STANDARD FIELD SERVICE BULLETIN

FSB Number	CHRAEFSB2016-19 Rev. 2
Author	Tony Bryan
Date	11/07/2016
Subject	Moto G4 Plus, Moto G4 - Touch Screen, Auto-Selects (ghost touches)
Model Affected	XT164x, XT162x
Level Of Repairs	Level 2

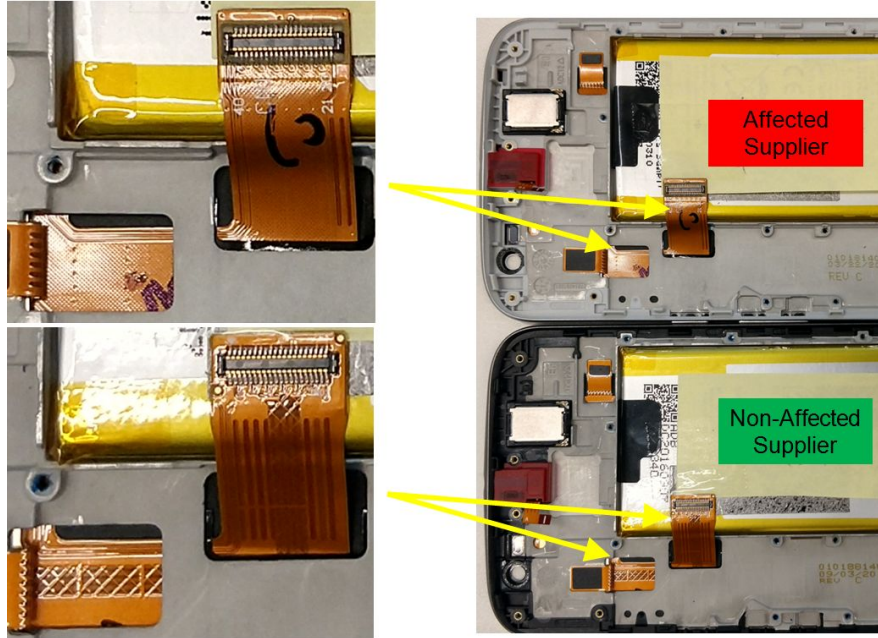
When servicing customer returns on the Moto G4 / Moto G4 Plus products with complaints related to "Touchscreen, Auto-Selects (ghost touches)", then:

1. Regardless of test result, disassemble device and replace the Display/Touch Panel using ONLY the non-affected supplier part numbers.
2. Reassemble and complete full functional testing, per SOP, to ensure proper repair.
